REGULATION No. 116 (Protection of motor vehicles against unauthorized use)

Revised proposal for draft amendments to Regulation No. 116

Submitted by the expert from Japan

Paragraph 6.4.2.1.

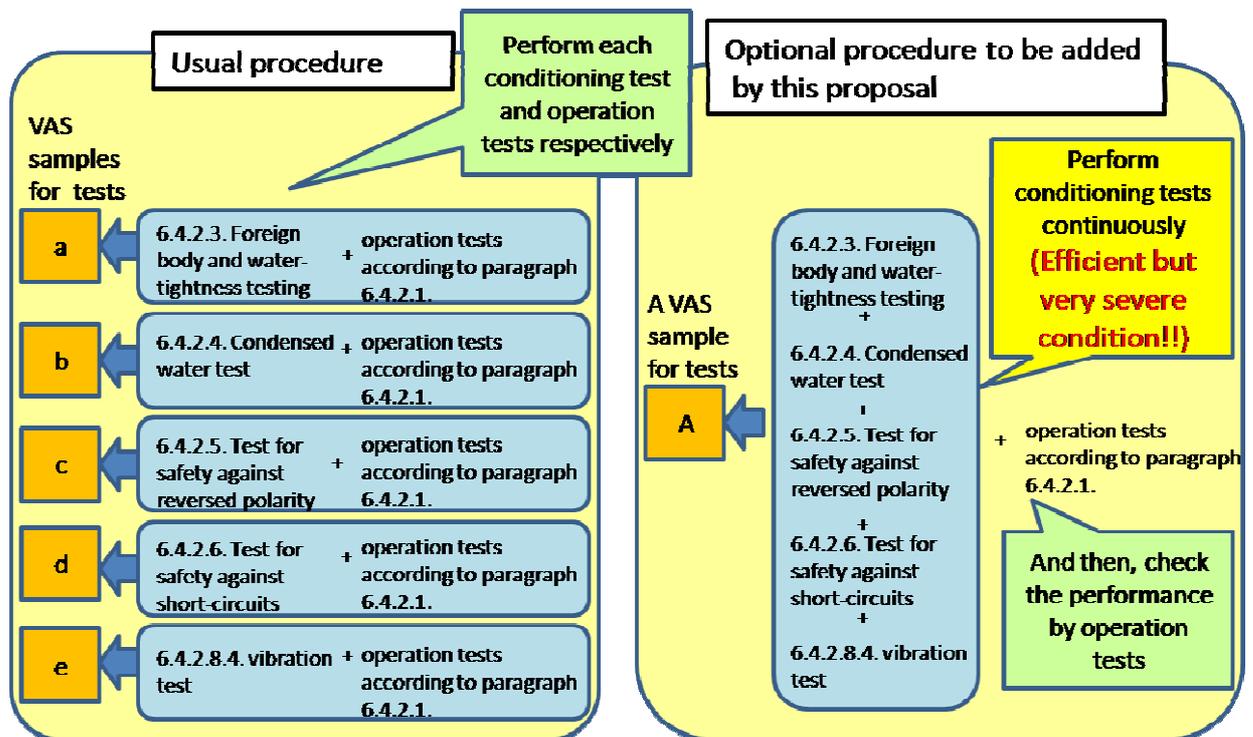
This proposal is to add an optional procedure for this Regulation to streamline the operation tests repeatedly required according to paragraphs 6.4.2.3., 6.4.2.4., 6.4.2.5., 6.4.2.6. and 6.4.2.8.4. by adopting more rigorous conditions.

Performing some of the tests required in these paragraphs prior to the operation tests in series for a sample is more rigorous than performing one of these tests before performing the operation test with regard to test conditions.

This amendment enables exemption of the tests for a VAS approved as separate technical unit or an AS to be installed to the vehicle which is type approved. It is possible to apply vehicle type approval of the immobilizers and alarm systems without the type approval for components/separate technical unit, while some devices to prevent unauthorized use are not subject to such component type approval.

For the operation tests required according to paragraphs 6.4.2.3., 6.4.2.4., 6.4.2.5., 6.4.2.6. and 6.4.2.8.4., if some of the tests required in each of these paragraphs prior to the operation tests are performed in series on a single VAS, the operation test may be carried out one time only after the chosen tests are completed instead of performing the operation tests required in the paragraphs after each of the chosen tests. "
